# Corporate Report

Originator's  
Files OZ 07/012 W11

**SUBJECT:** **Information Report**  
**Official Plan Amendment and Rezoning Applications**  
**To permit a three-storey retirement dwelling**  
**38, 40 and 44 Main Street**  
**North side of Main Street, west of the Credit River**  
**Owner: Gova Enterprises Inc.**  
**Applicant: Wellings Planning Consultants Inc.**  
**Bill 51**

SITE STATISTICS:

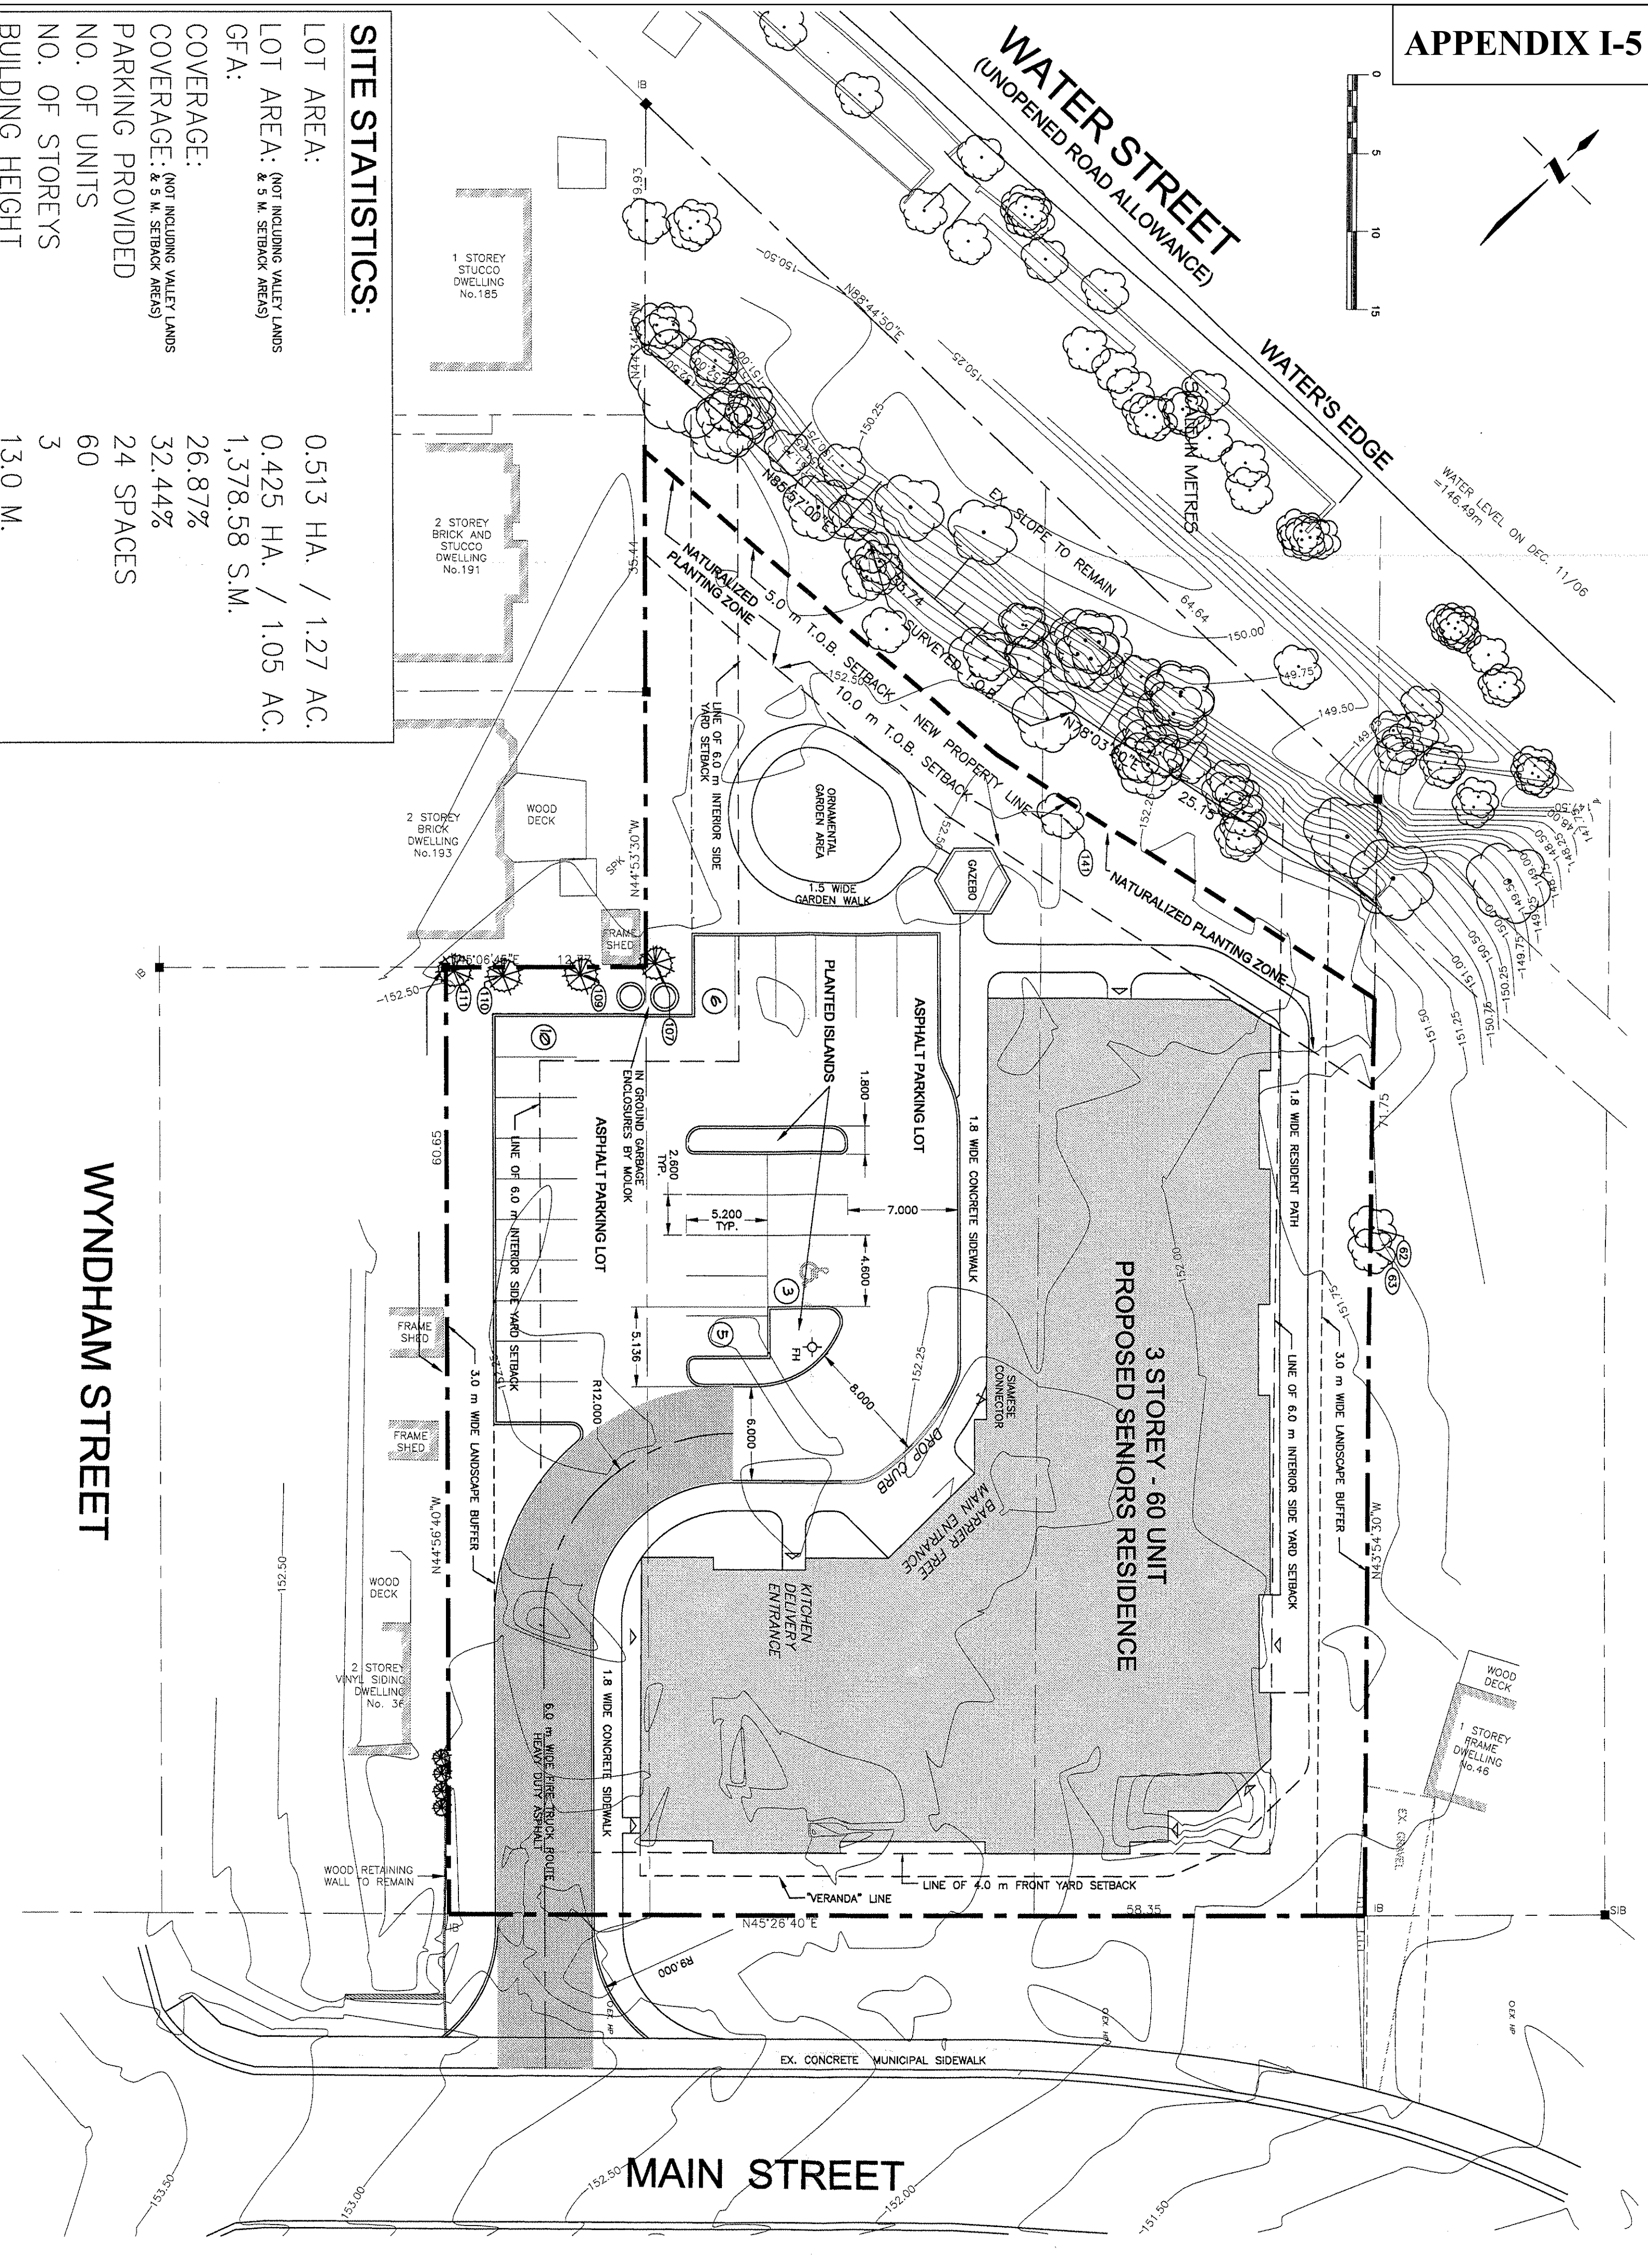
The massing of the building is significant and should be setback from the street, or the design of the elevation should be modified to have less impact on the streetscape.

Based on all of the drawings received to date, staff have suggested that the setback between the building and Main Street be increased to be more in line with the existing setbacks to the detached dwellings on either side of the proposal. In addition, the increased setback would assist in improving the pedestrian experience along this portion of Main Street by moving the massing away from the sidewalk. The increased setback would also allow for more landscaping to be provided as is desired.

Alternatively, it has been suggested by staff that the proposed 4.50 m (14.76 ft.) setback may be appropriate if the design of the building was more in keeping with the traditional architecture typically found in Streetsville and enhanced the character of the community. A more appropriate design would also include some

relief in the massing by including projections and indentations, and a prominent, principal pedestrian building entrance on Main Street.

The development is proposing in-ground garbage enclosures. The Region of Peel cannot service these types of enclosures. The applicant should revise the proposal to include a waste collection area that complies with the specifications of the Region's Waste Collection Design Standards Manual. An alternative is to arrange for private waste collection, however, private waste collection is not permitted for residential developments unless approved by Regional Council.

The shadow study submitted as part of the Urban Design Study does not conform with the City's Design Reference Note "Standards for Shadow Studies" in relation to allowances for sunlight on residential amenity spaces. Based on the submitted study, the shadow from the proposed building will affect the rear yard amenity space of the property located immediately to the east. The applicant should look at alternative building designs or provide further detail that would rationalize the acceptability of the shadowing impacts.

The above issues are being considered by staff. Further analysis is required and issues related to the design of the building, the proposed density and compatibility will be addressed in a future Supplementary Report.
